Wollongong Local Planning Panel Assessment Report | 16 November 2021

WLPP No.	Item No. 3
DA No.	DA-2021/321
Proposal	Mixed Use Development comprising retail shops, gymnasium, childcare centre, basement parking and six (6) awning signs
Property	429-431 Princes Highway, WOONONA NSW 2517
Applicant	Mr Michael Trinh
Responsible Team	Development Assessment & Certification – City Wide Planning Team (RT)

ASSESSMENT REPORT AND RECOMMENDATION

Figure 3: Height plane diagram with maximum building height of 11.95m for the lift overrun and 11.4 for the roof circled in red.

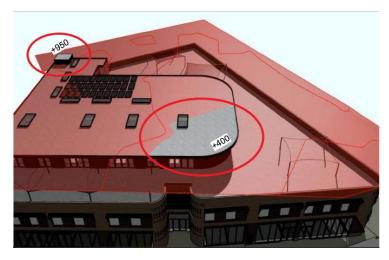
The building departs from the development standard (as depicted by the grey shaded areas circled in red in the diagrams below) as follows:-

The proposed mixed use building has an overall height of 11.95m to the lift overrun and 11.4m to the roof which exceeds the maximum height of 11m shown for the land on the Height of Buildings Map. See Figure 3 below.

- The 0.45m exceedance of the 11m height limit by the roof slab is due to site topography and the need to adopt consistent FFL's to the first and second floor which provides for a better functionality outcome for the recreation facility and the child care centre than a split level floor would otherwise provide.
- The additional height is not anticipated to result in detrimental environmental planning outcomes, with respect to adverse solar access, or visual or acoustic privacy impacts on site, or to neighbouring properties.
- The departure to the height standard furthers the objects of the Environmental Planning and Assessment Act 1979 as set out below:
 - To promote the orderly and economic use and development of land;
 - To promote good design and amenity of the built environment through the provision of suitable finished levels to the development and the provision of lift access.;

Figure 4: Height plane diagram of the roof showing skylights and solar panels exceeding the 11m height circled in red.

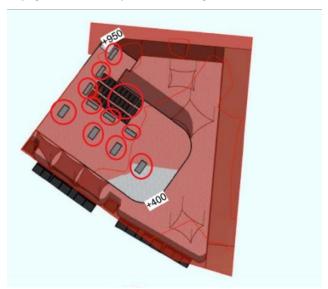
Elsewhere elements of the building slightly exceed the 11m height limit. The following lists the extent of the departures:

Skylights and solar panels. See Figure 4 below.

ANNEXURE 1: CLAUSE 4.6 VARIATION REQUEST - BUILDING HEIGHT

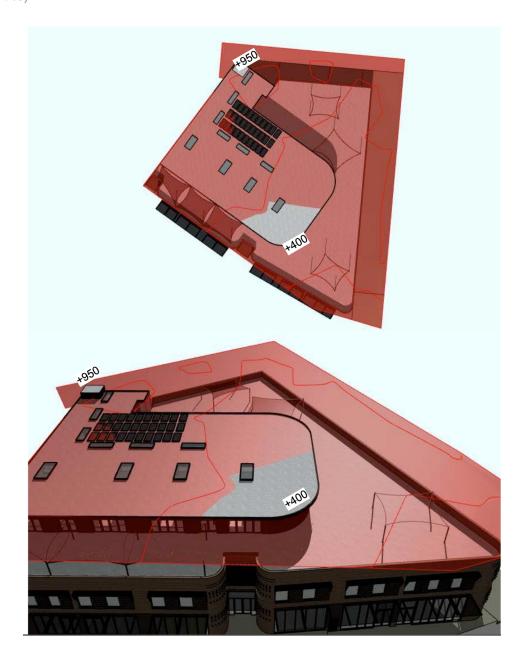
The 3d height plane on the architectural plans shows the extent of departure visually noting it is limited to the upper portion of the roof element only and the lift over-run. The building roof exceeds by only 400mm (3.6%) and the lift over-run by 950mm (8.6%).
